Mi98-36

DATE :August 1998SECTION : 22SUBJECT :Improvement of the Condenser Fan Circuit

In case of a R29 relay failure, one of the two fan motors can be kept working by modifying the electrical circuit of the condenser fan.

**Figure 2:** Initial aspect of relay R29 in A/C junction box.

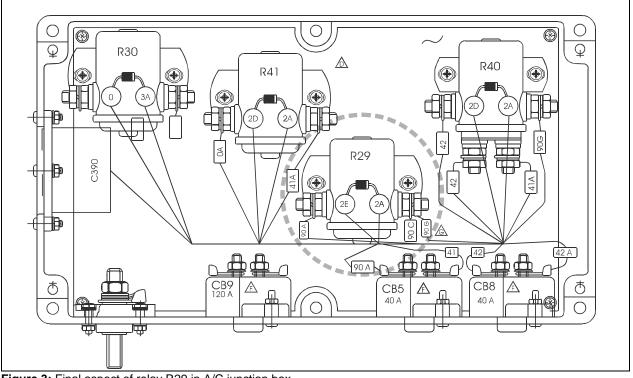
- 2. Find the R29 relay in the A/C junction box (see figure 2);
- 3. Remove wire 90G from relay R29 and relocate it on the other R29's terminal (on the side of wire 90C). The result of this change is shown on figure 3;
- 4. Put lid back and close the condenser compartment door. Replace the former electrical diagram by the new one given in the appendix.

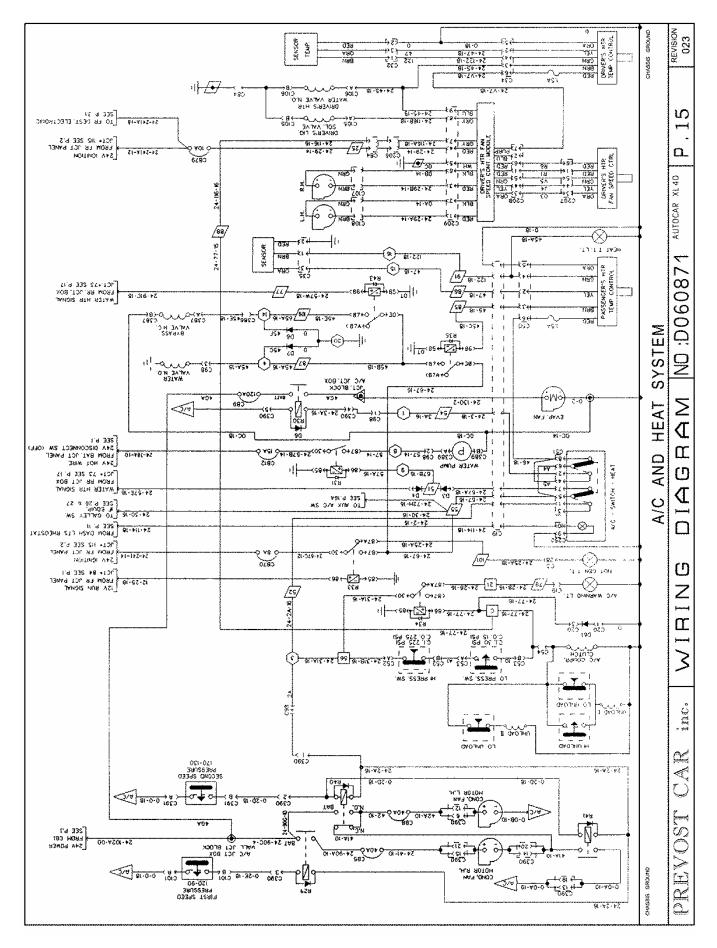
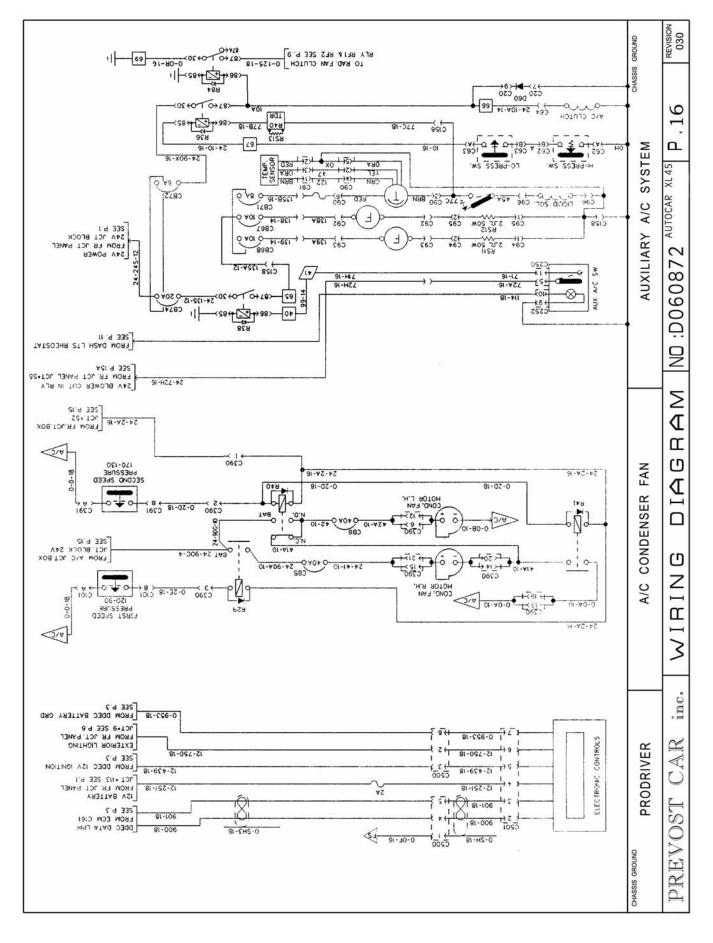
- Appendix 1 applies to M-40 and to M-45E;
- Appendix 2 corresponds to XL-40 Coaches;
- Appendix 3 is applicable for XL-45 Coaches.
